**Addendum No. 1
BL162-23
Harris Elementary School Fire Flow Improvements**

The following addition/changes modify the Bid No. BL162-23 "Harris Elementary School Fire Flow Improvements" Contract Documents, dated November, 2023, as first advertised on November 08, 2023.

Harris Elementary School Fire Flow Improvements

CD.04

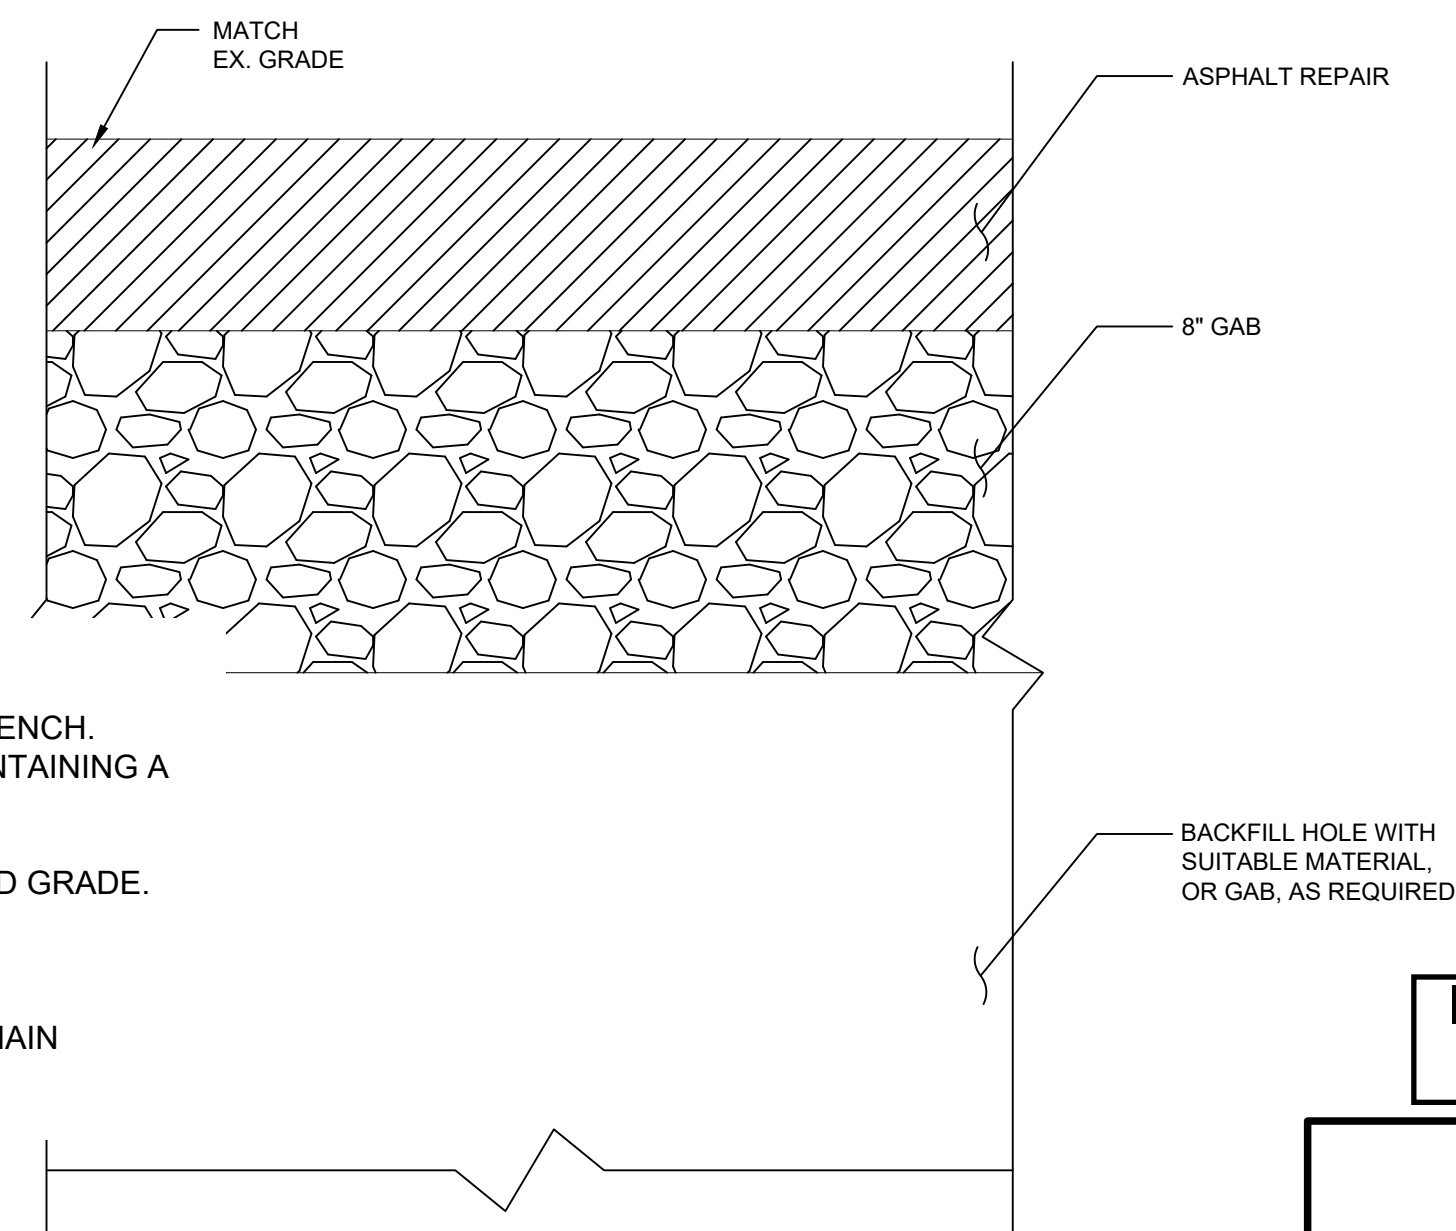
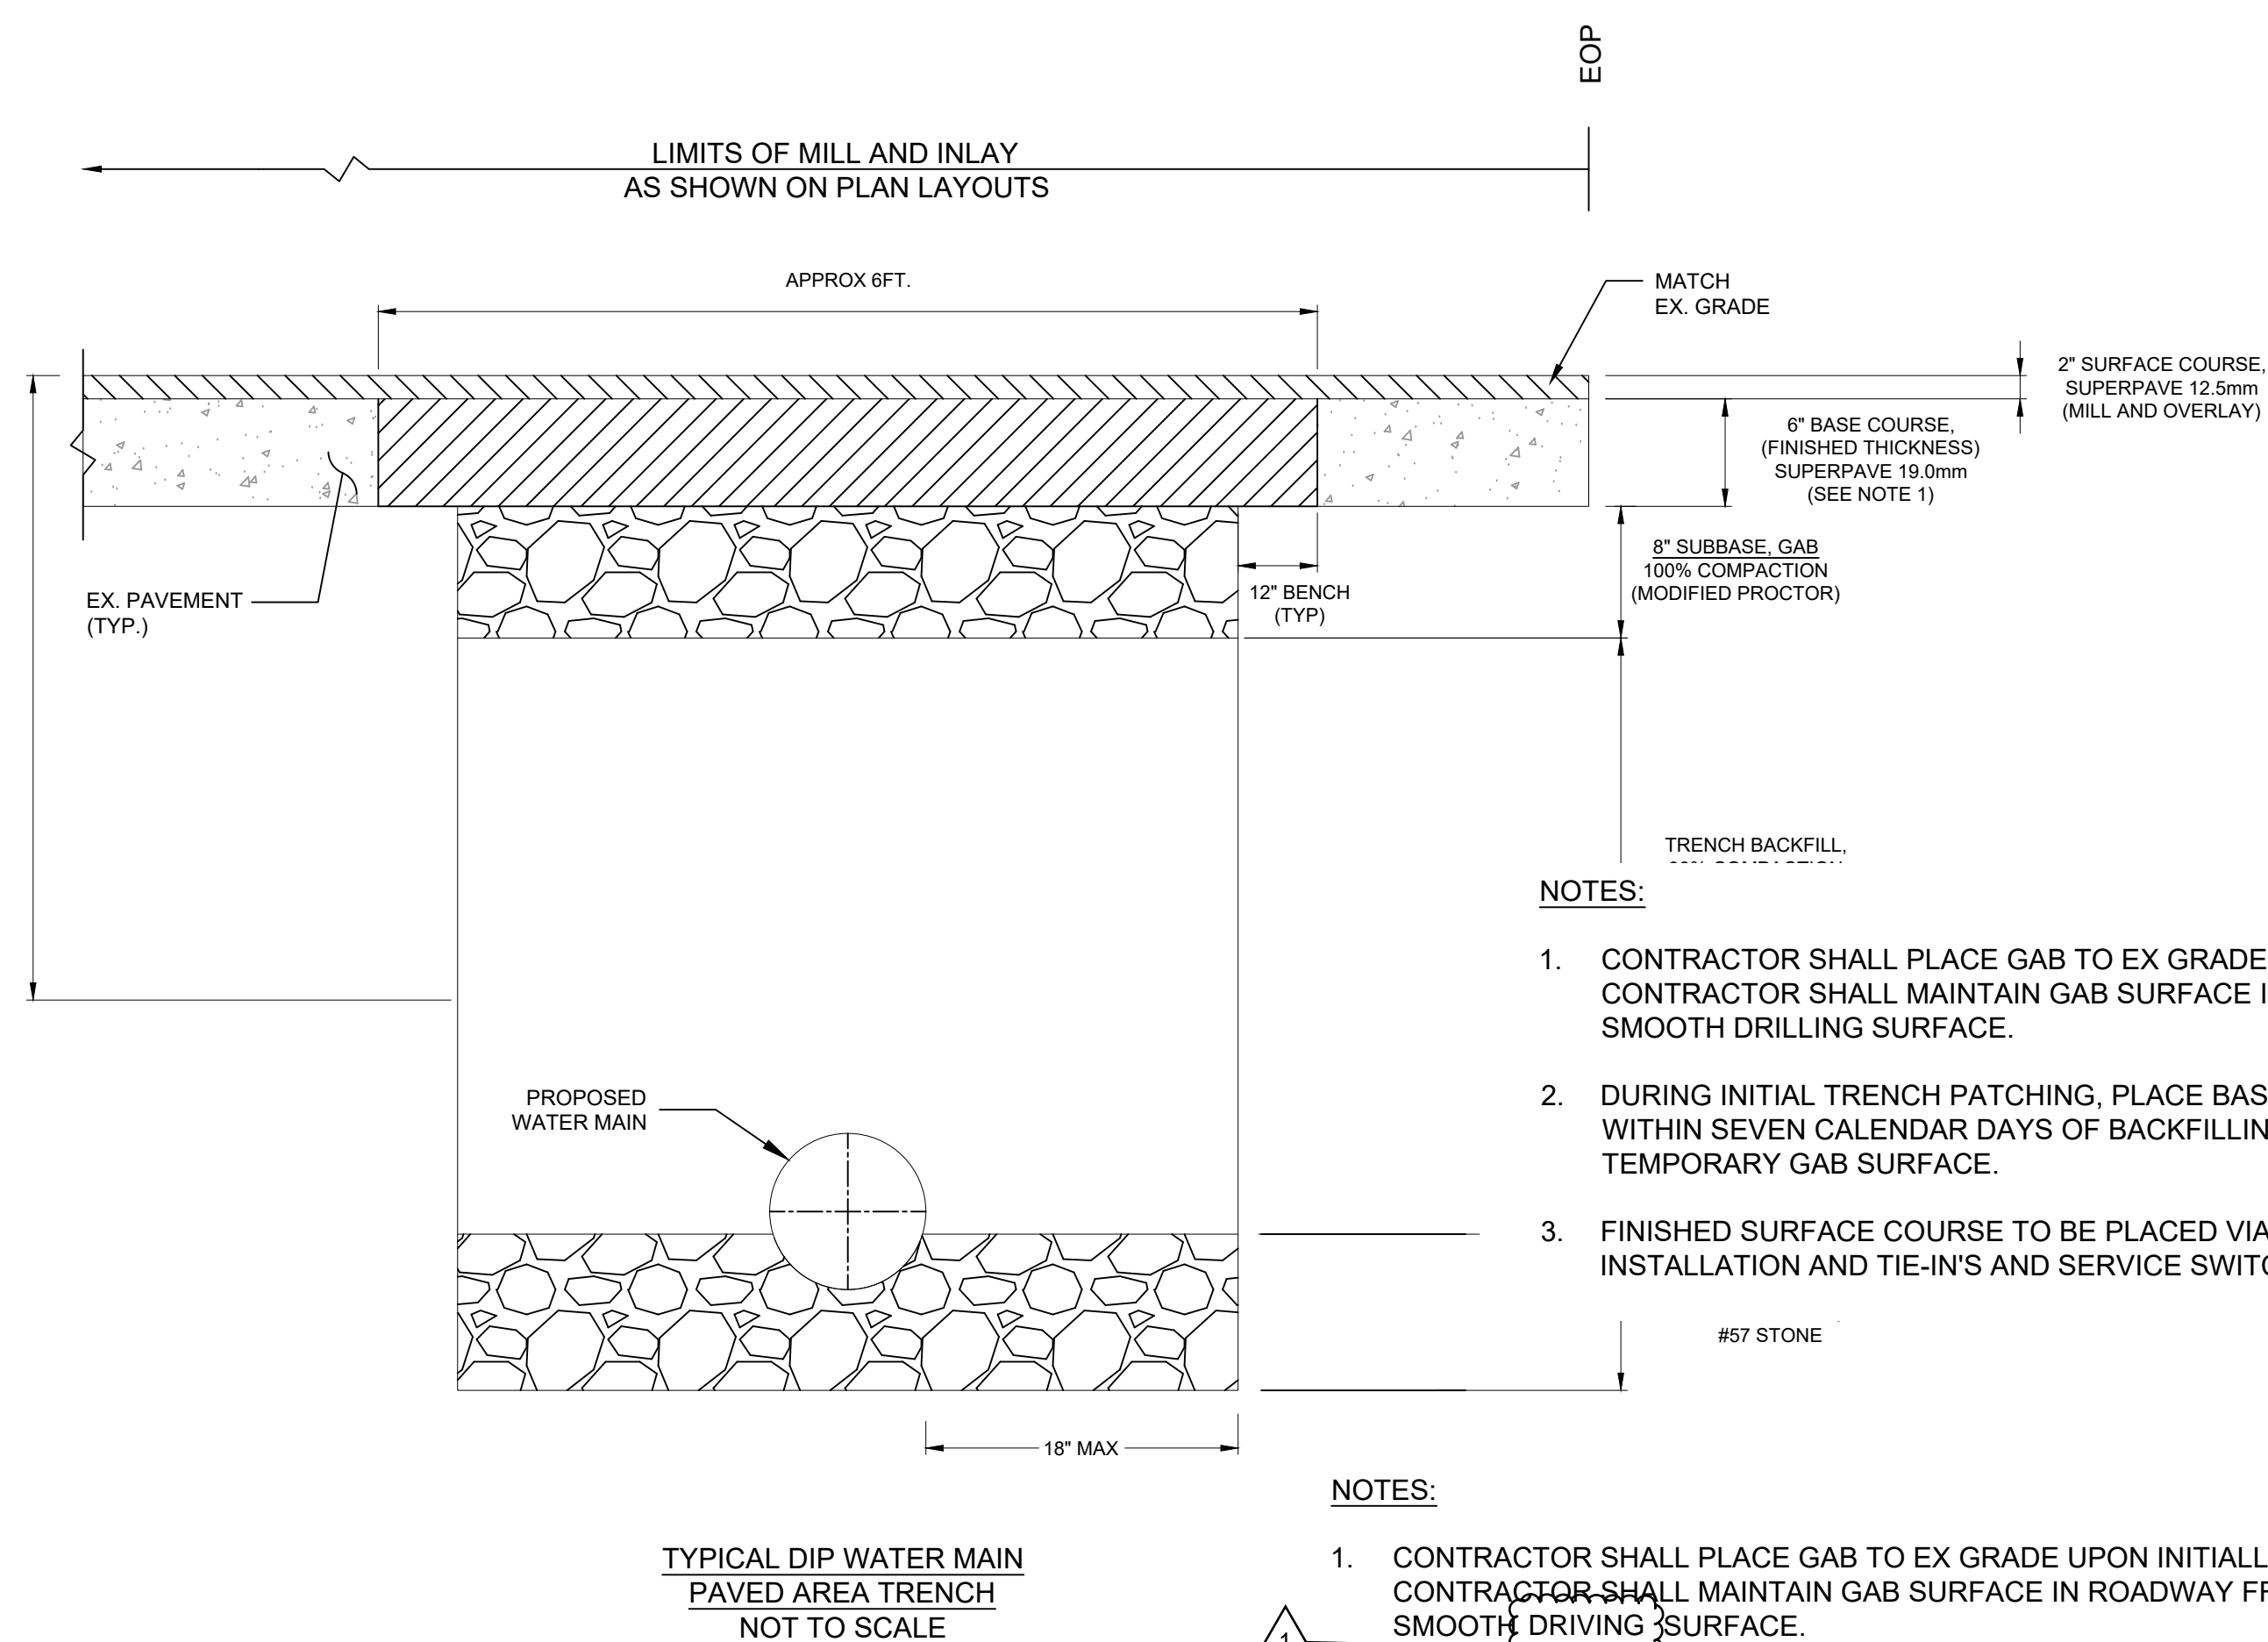
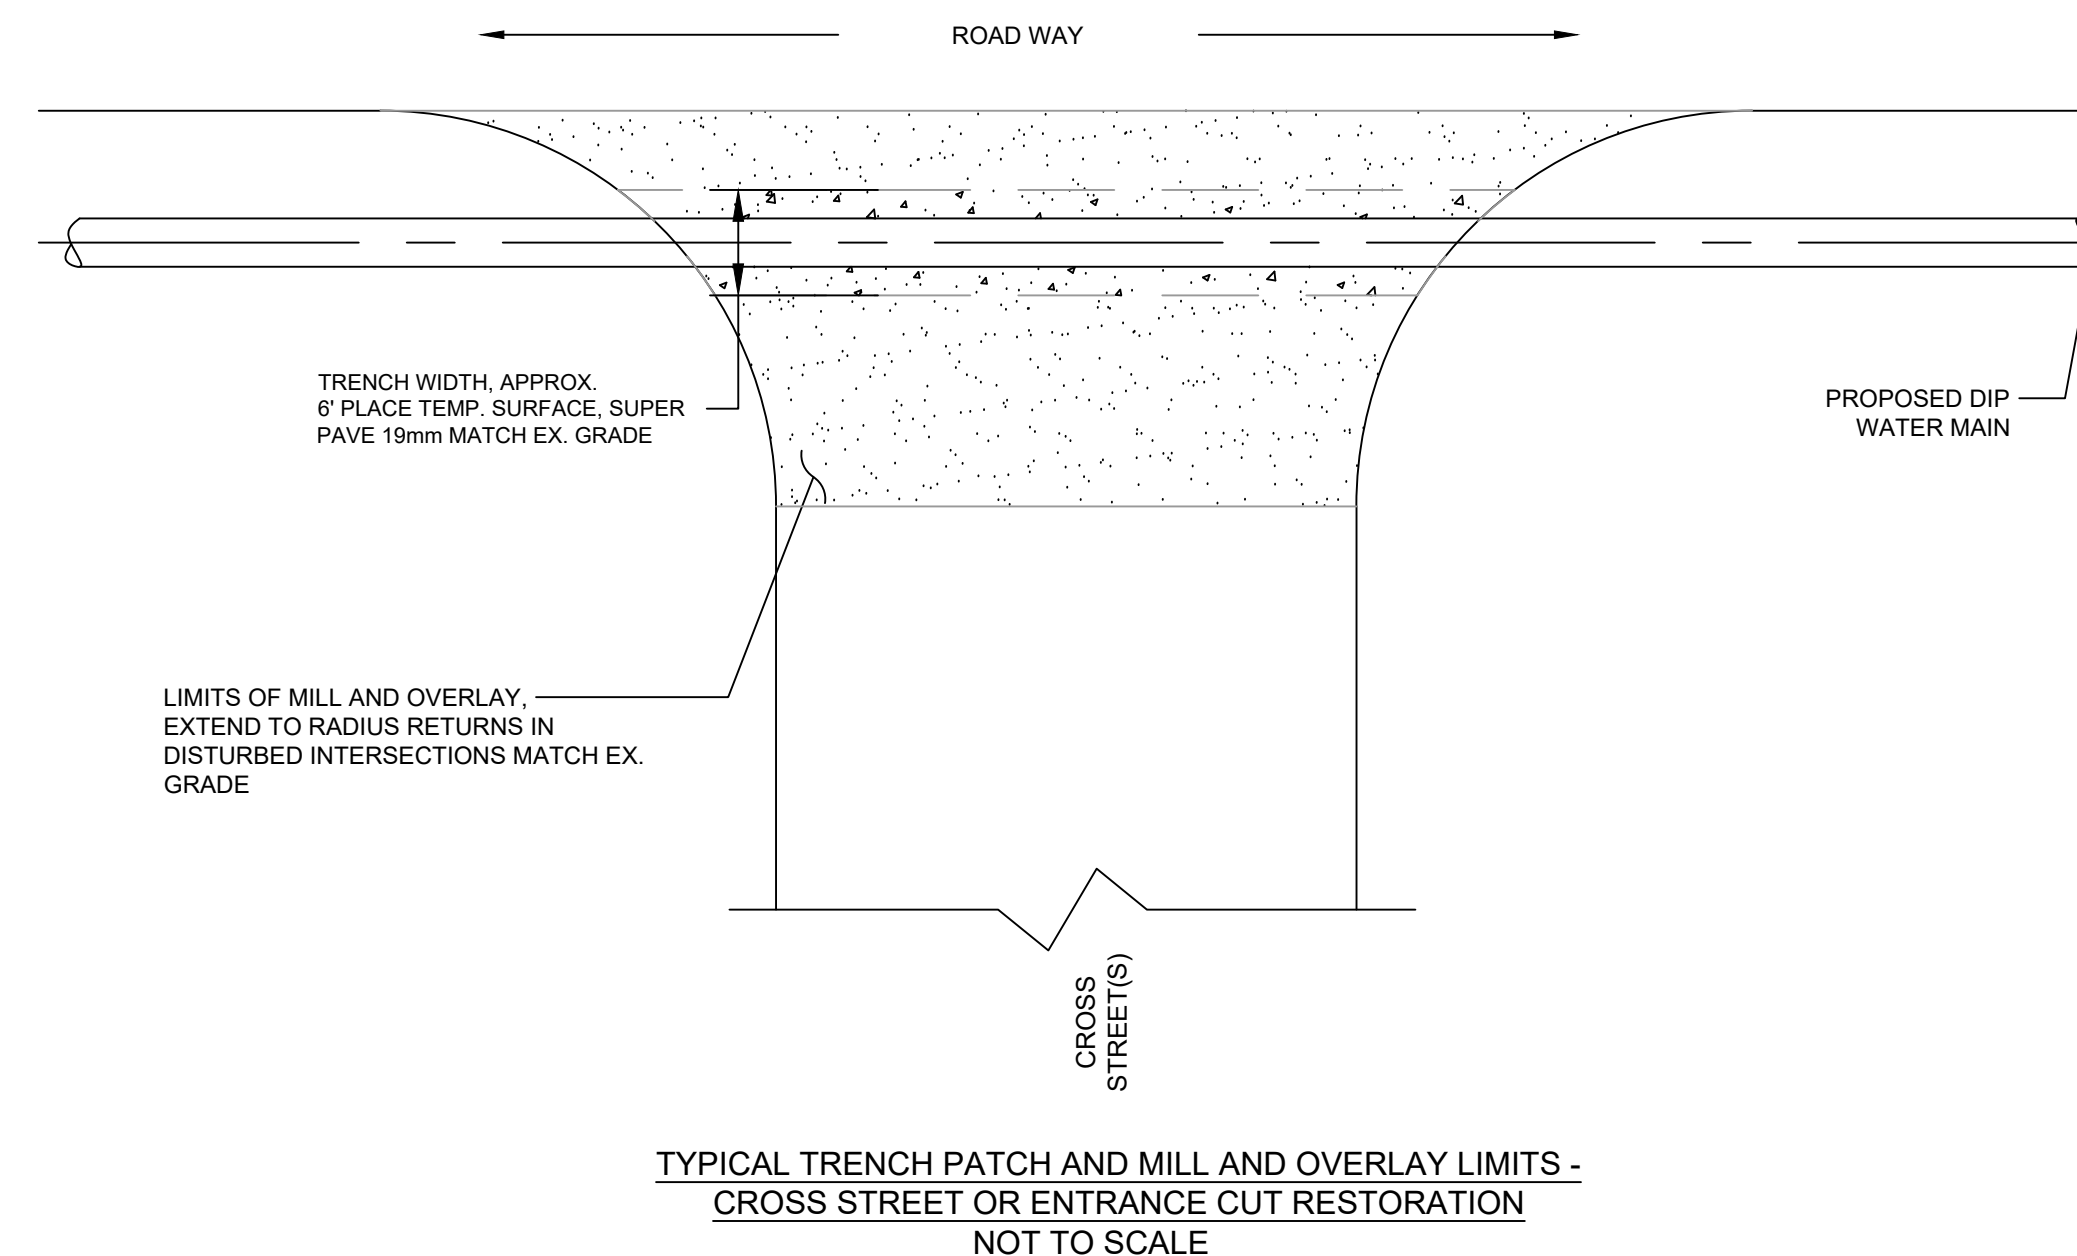
- Q1. Plan page CD.04 Note 1. Will this Gab as described be paid under line item #12 for its usage to stabilize the road during construction?
A1. Yes.
- Q2. There is no borrow line item - will it be paid under Engineered Directive Earth excavation removal and replacement if soil is deemed not meeting standards?
A2. Removal is paid for with Item ODW5 Earth Excavation. Replacement material will be Additional Pipe Bedding paid for under Item ODW4 Additional Pipe Bedding.

- Q7. Please confirm compaction is 95% or 100% under roadway.
A7. See detail titled "Typical DIP Water Main Paved Area Trench" on Drawing CD.04.
- Q8. Will hydrants be paid complete as the bid tab does not note Type A Hydrant? Several hydrants are not on the mainline so I wanted to confirm 6" DIP will be paid by the foot off the hydrants.
A8. Correct, fire hydrant assemblies are inclusive of all hydrants regardless of Type A or not. Specification Section 01 22 15.11, Standard Pay Item Description 36 stipulates pipe is included in the cost of the assembly.

- Q15. For rock removal payment is the lesser of the payable trench width the actual trench width excavated in the field as described in 01 22 15.11, 5.a or, a maximum of 4.45' as shown in "Typical DIP Water Main Paved Area Trench" Detail found on Sheet CD.04?
A15. Maximum rock removal pay limits shall be as described in Specification Section 01 22 15.11, 5.a.

1. Drawing CD.04, Detailed Titled "Typical DIP Water Main Paved Area Trench"
REVISE the second to last word of Note 1 to read "driving".
2. Drawing CD.04, Detailed Titled "Typical DIP Water Main Paved Area Trench"
ADD the following Note 4: "Where use of steel plates over the trench is necessary to provide a temporary driving surface during the course of construction, the contractor shall provide steel plating and associated temporary asphalt to anchor steel plating in place at no additional cost to the Owner. Such work shall be considered incidental to the project and shall not be measured or paid for separately."

- NOTES:
- CONTRACTOR SHALL PLACE GAB TO EX GRADE UPON INITIALLY BACKFILLING TRENCH. CONTRACTOR SHALL MAINTAIN GAB SURFACE IN ROADWAY FREE OF RUTS, MAINTAINING A SMOOTH DRIVING SURFACE.
 - DURING INITIAL TRENCH PATCHING, PLACE BASE COURSE MATERIAL TO FINISHED GRADE. WITHIN SEVEN CALENDAR DAYS OF BACKFILLING TRENCH AND PLACING INITIAL TEMPORARY GAB SURFACE.
 - FINISHED SURFACE COURSE TO BE PLACED VIA MILL AND INLAY AFTER WATER MAIN INSTALLATION AND TIE-IN'S AND SERVICE SWITCH OVERS ARE COMPLETE.

1. WHERE USE OF STEEL PLATES OVER THE TRENCH IS NECESSARY TO PROVIDE A TEMPORARY DRIVING SURFACE DURING THE COURSE OF CONSTRUCTION, THE CONTRACTOR SHALL PROVIDE STEEL PLATING AND ASSOCIATED TEMPORARY ASPHALT TO ANCHOR STEEL PLATING IN PLACE AT NO ADDITIONAL COST TO THE OWNER. SUCH WORK SHALL BE CONSIDERED INCIDENTAL TO THE PROJECT AND SHALL NOT BE MEASURED OR PAID FOR SEPARATELY.
